GPSMAP 185 Sounder Addendum

July, 2010 190-00158-02 Rev. A Printed in Taiwan

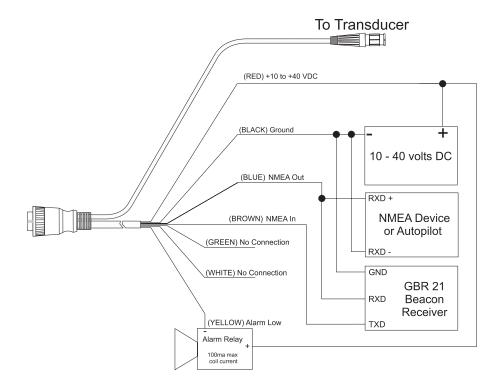
The power/data/transducer cable wiring diagram on page 85 of the GPSMAP 185 Sounder Owner's Manual (part number 190-00158-10), incorrectly indicates that the brown wire on the cable is NMEA Out and the blue wire is NMEA In.

The blue wire is NMEA Out and the brown wire is NMEA In, as indicated in the corrected wiring diagram below.
